### Consideration on Geology of Bagong Damsite

## Suggestion on Treatment of Colluvium at Bagong Damsite Right Abutment and Spillway Foundation

JICA Dam Construction Advisors  
Hiroshi Shimizu  
Naoya Mizuno

## Site Inspection Report

Figure-2 Geological cross section of the dam axis.

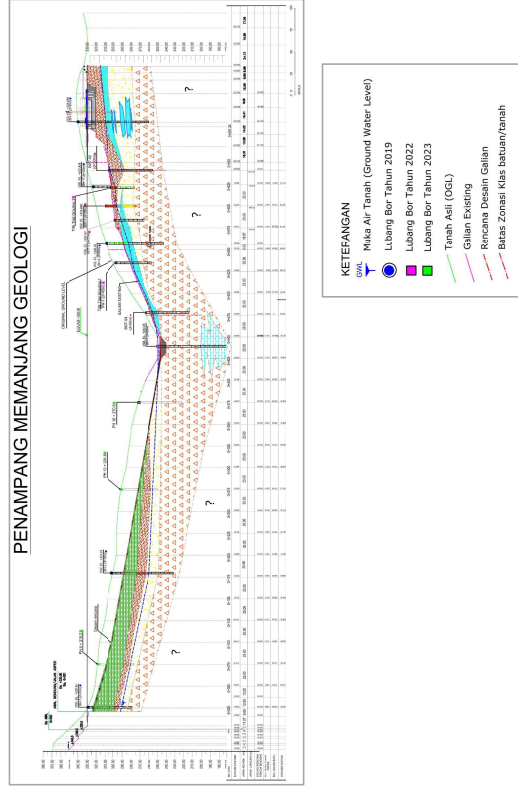
- The dip of the strata observed during the field visit is almost horizontal to less than  $10^\circ$ . However, according to the geological cross section of the dam axis shown in Figure-2, the distribution altitude of limestone is slightly different between the right and left banks, which may indicate the distribution of old faults in the riverbed (which can be confirmed by excavating of the riverbed area).

Figure-3 Schematic diagram of rock creep on the right bank

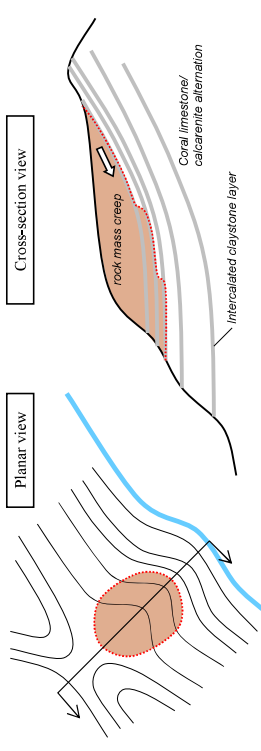
colluvium has crept or moved as a mass. The slope is close to the summit, indicating that the distance over which the mass has moved is short (Figure-3).

- Based on the material provided for the site inspection and interviews with the site engineer, the distribution area of the colluvium is estimated to be approximately the area indicated by the red circle in the Figure-3.
- According to Google Earth satellite imagery, no landforms suggestive of land sliding (e.g. slip cliffs, gentle gradients at the head) are recognized around the slope, and the short distance of movement is estimated to be rock mass creep.

**Photo-5 Core samples from borehole BGT-5 at depths of 15-20 m**  
Highly plastic clays are recognized at depths of 17-19m.

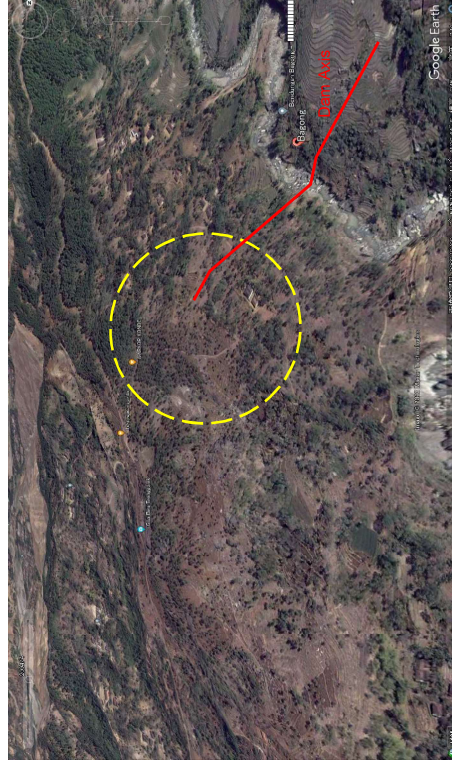
- In general, the slip layer consists of highly plastic clay. Due to the shear surfaces (foliation) caused by creep and sliding, they are anisotropic in strength and have a lower strength than normal clays. During the site inspection, highly plastic clay was observed at a depth of 17-19 m in borehole BGT-5 (Photo-5).

- In the site plan, the strength of the colluvium is set at  $c = 24.5 \text{ kPa}$  and  $\phi = 16^\circ$  for both the left and right banks. These values generally correspond to the strength of softer clay layers. However, clays in slip layers may have an internal friction angle of less than  $10^\circ$  due to the development of shear planes.

**(b) Comments on the Separate Wall between Dam Body and Spillway**

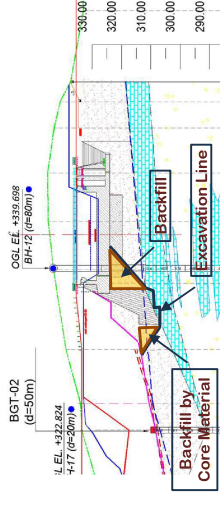
It is supposed that the wall was designed on a limestone as its foundation under the condition that the limestone would have sufficient bearing capacity since. However, the concrete piles for spillway support have penetrated through the limestone layer and into the sandstone layer. It is not clear why the design is.

Since the height of the wall is 27.5 m, it is recommended to confirm the strength of limestone and modify the design of the wall foundation or pile foundation, if necessary.

**(iii) Shape of Core Foundation**

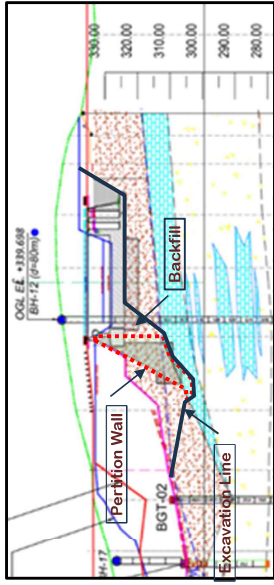
If deep excavation and remain the Colluvium, it is necessary to pay attention a design of connection point of the wall and core foundation. Generally, core foundations are excavated smoothly without leaving noticeable protrusions, but in the current design, the toe of the concrete protrudes, so it is recommended to lower the foundation another around 1 meter and embed it in Limestone.

**Figure 2** Fault Crossing Core Foundation

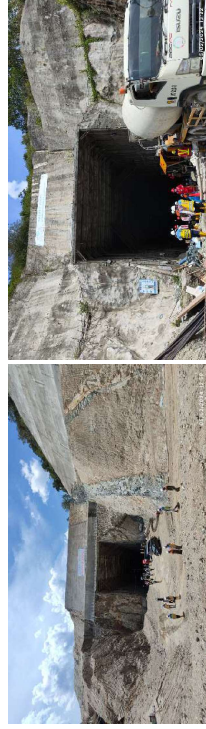
At present, although the details of them are not confirmed because the foundation excavation has not been completed, it is supposed that these issues will not be a critical problems considering the scale of fault.

Since the core foundation of Bulango Ulu Dam will be covered with grout cap concrete, it is recommended that to conduct a trench excavation and replace it with concrete along the fault at the core foundation area, if necessary.

Figure 1 Sketch of Bagong dam design with remain colluvium deposit

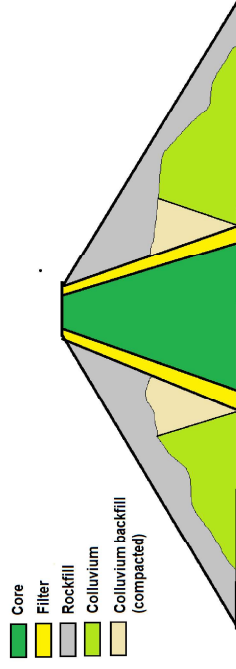
shown Figure 1 (should be confirmed by stability analysis).

Figure 2 Colluvium at right abutment foundation

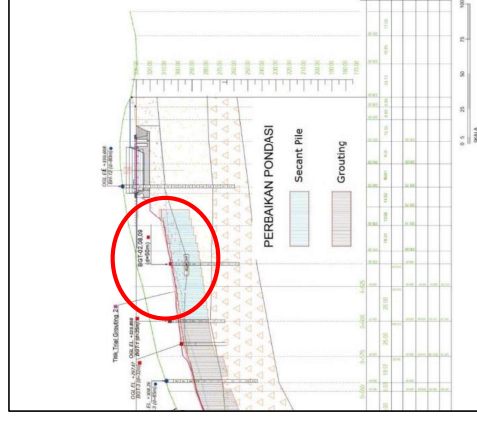
(4) at the right abutment near the spillway, the dam foundation is still on colluvium. It recommended that all colluvium deposits should be removed and replaced with dental concrete or all replaced with core fill material completely (removing the installed secant piles as well).
